APPENDIX A  
EPRI COMMENTS ON THE EPA PHASE II PROPOSED 316(b) RULE  
AND NOTICE OF DATA AVAILABILITY

May 26, 2003

**Review of Comments by Pisces, Ltd. On EPA' 316(b) Case Study Analysis  
Review of Modifications to the Case Study Methodology Documented in EPA's  
Notice of Data Availability**

Figure 1. Power functions fitted to Great Lakes entrainment and impingement loss data (from Kelso 1979), compared to linear approximations over the same flow range.

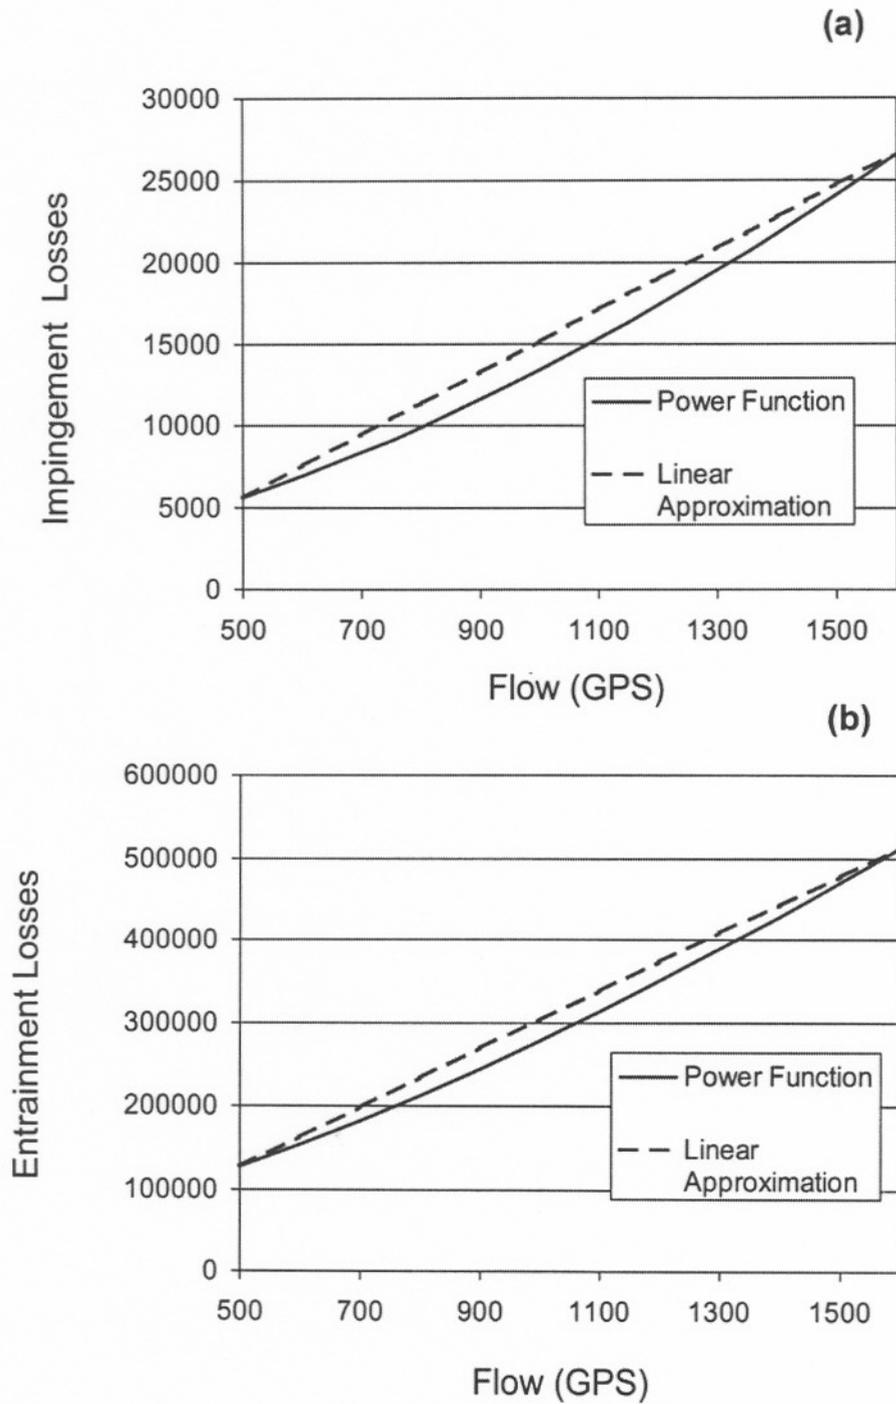
Pisces cited a paper by Kelso and Milburn (1979) as support for the proposition that impingement and entrainment are nonlinearly related to flow. These authors examined entrainment and impingement data for 37 power plants located on the Great Lakes, and developed empirical equations relating flow rate, entrainment, and impingement. Both equations are both power functions, implying that entrainment and impingement increase exponentially with flow. Clearly, since the data relate to the Great Lakes and are more than 25 years old, the equations themselves are irrelevant to evaluation of EPA's analysis. Moreover, as is shown in Figure 1, the quantitative significance of the non-linearity described by Kelso and Milburn (1979) is trivial. Figures 1a and 1b plot entrainment and impingement rates calculated from the equations provided in the Pisces analysis over an arbitrary range of 500 to 1600 gallons per second (the actual range of flows used is irrelevant – the plots would look the same over any range of flows). Along with curves calculated using the power functions from Kelso and Milburn (1979), each plot shows a linear approximation calculated by drawing a straight line connecting the two ends of the curves. It is clear that the degree of non-linearity is small. For any given flow rate, the differences between the curves and the lines are probably much smaller than the uncertainty (not discussed by Pisces) in the impingement or entrainment rate expected at any given flow. Moreover, at every flow rate, the linear approximations *overestimate* the loss estimates obtained using the power functions.

Figure 2. Relative contribution of different age groups to total losses of white perch at Salem, over all available years, expressed as age-1 equivalents, foregone yield, and foregone reproductive potential.

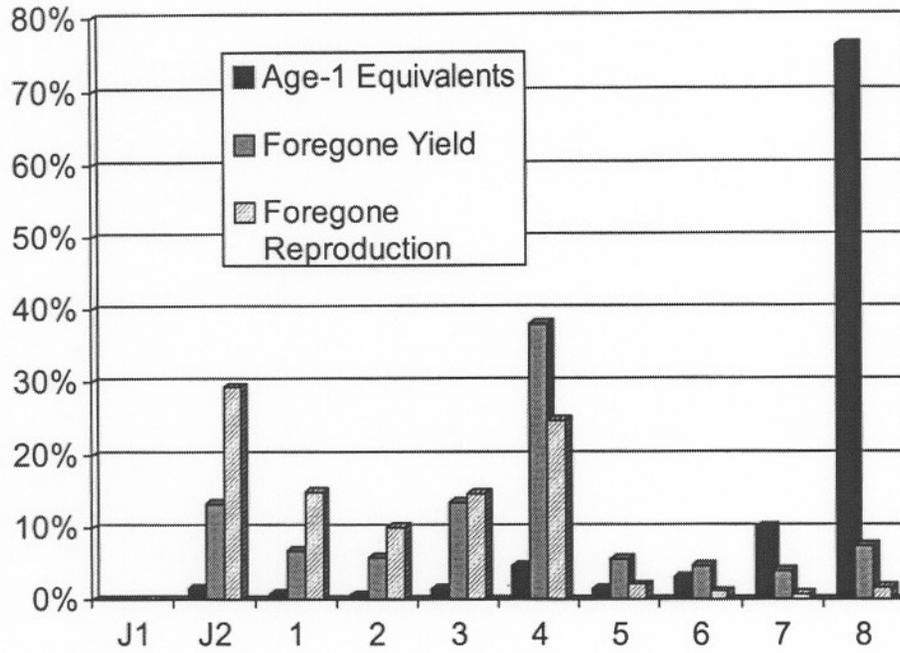
In Table 6 of its analysis, Pisces calculated numbers of equivalent 1-year olds, by age group, for the total numbers of all RIS fish species collected over all available years of sampling at Salem. Figure 2 of my comments compares estimates of equivalent 1-year-olds (recalculated using correct mortality rates), yield foregone, and production foregone for each white perch age group. The following equations were used to make these calculations:

All parameters in the above equations except for the loss rates were taken from Appendix L, Tab 18 of the Salem filing (PSEG 1999). Figure 2 shows that white perch impinged at an age of eight years, which account more than 75% of the age-1 equivalent losses as calculated using Pisces' method, account for only 7% of the total yield foregone and for less than 2% of the total reproduction foregone. It is true that assuming that age 1 and older fish are impinged at age 1 underestimates the yield and reproduction foregone due to impingement, however, the magnitude of the bias is much smaller than is implied in Pisces' analysis. Pisces's assertion that impingement losses – when measured in terms

that are relevant for impact assessment and benefits analysis – are similar in magnitude to entrainment losses is erroneous.

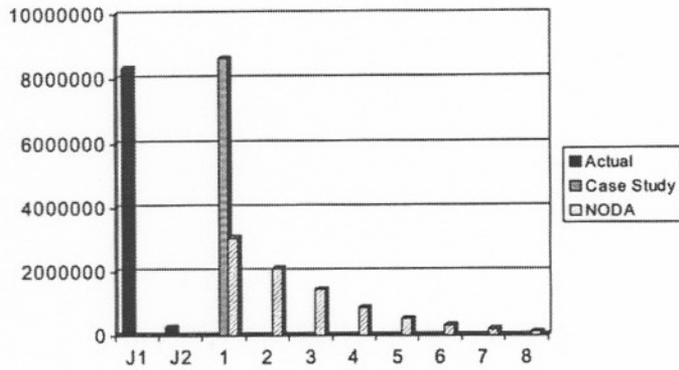
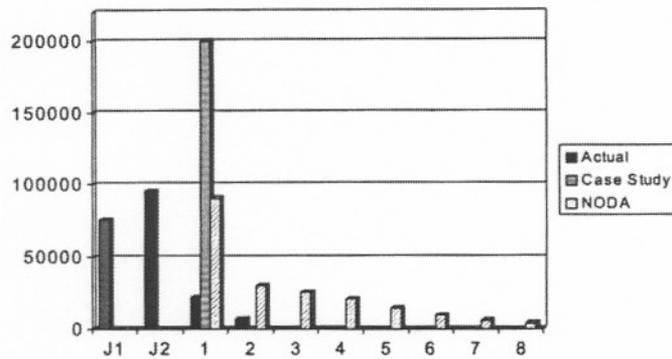
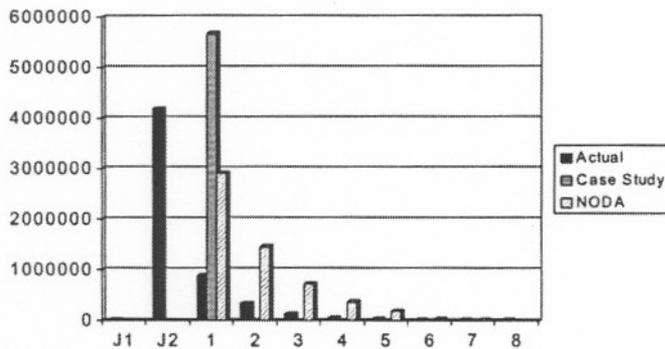
The importance of these errors is demonstrated below, using the data for Salem provided in Docket No. 4-2051 to the Proposed Rule. The Salem data are used for this demonstration because, unlike the other input data files provided by EPA, the impingement data for Salem include a breakdown by life stage and age class. Figure 3 plots age distributions of fish impinged at Salem from 1990 through 1998 for three representative species: weakfish, striped bass, and white perch. The actual age distributions are compared to the distributions implied by EPA's original (proposed rule)

and revised (NODA) assumptions concerning the age distributions of impinged fish. For all three species, the impingement totals are comprised primarily of fish in the juvenile 1 and juvenile 2 life stages. Only 0.2% of weakfish, 15% of striped bass, and 26 % of white perch were age 1 or older. For only one of the species listed in the Salem input file, bay anchovy, do age 1 and older fish make up more than half of the total impingement losses. Figure 3 shows that, contrary to EPA's assumption in the NODA, no weakfish older than age 1 and no striped bass older than age 2 were reported in impingement collections at Salem from 1990 through 1998. White perch up to age 8 are impinged at Salem, however, even for this species EPA's assumed age distribution greatly overstates the proportion of fish impinged at ages older than age 1.

Figure 4. Comparison of foregone yield estimates calculated using the impingement loss estimates from Figure 1.

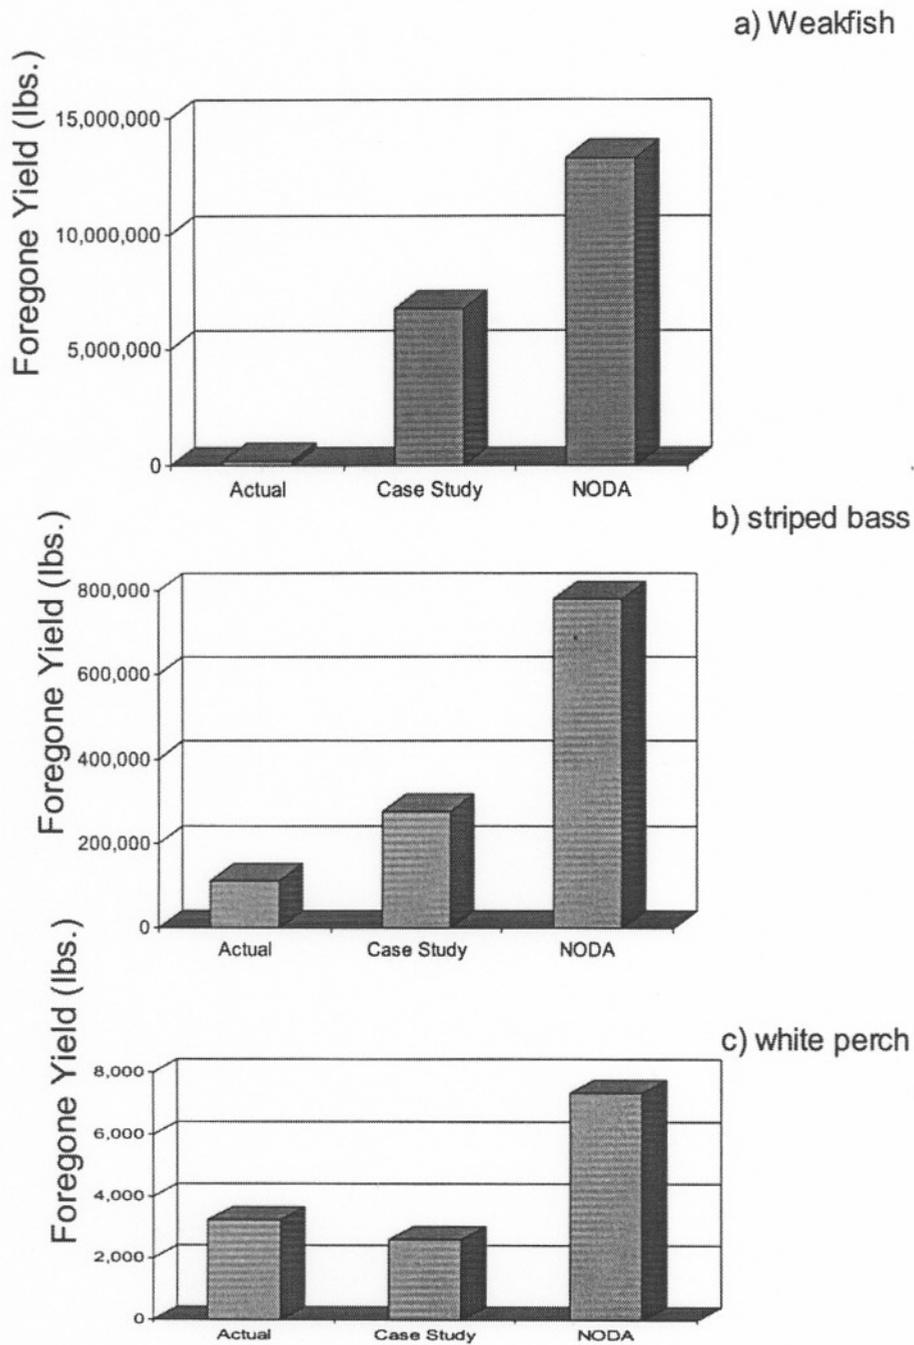
As in my comments on the Pisces report (above), I used Equation (1) to calculate the foregone yield due to fish impinged at each age or stage. This is the same yield equation used by EPA [see NODA, section X.B.3.b(1), 68 Fed. Reg. 13,545-46]. The total foregone yield due to impingement is obtained by summing the stage and age-specific values over all stages and age classes. Results of these calculations are shown in Figure 4. For all three species, foregone yield estimates calculated using the NODA assumptions are inflated compared to estimates calculated using actual age distributions. For weakfish, the NODA value is inflated by a factor of 70 times over the value calculated using actual age distributions. For striped bass and weakfish, assuming that all impinged fish are age 1 also greatly overestimates foregone yield. Only for white perch does the age-1 assumption underestimate foregone yield, and the difference in this case is only about 20%.
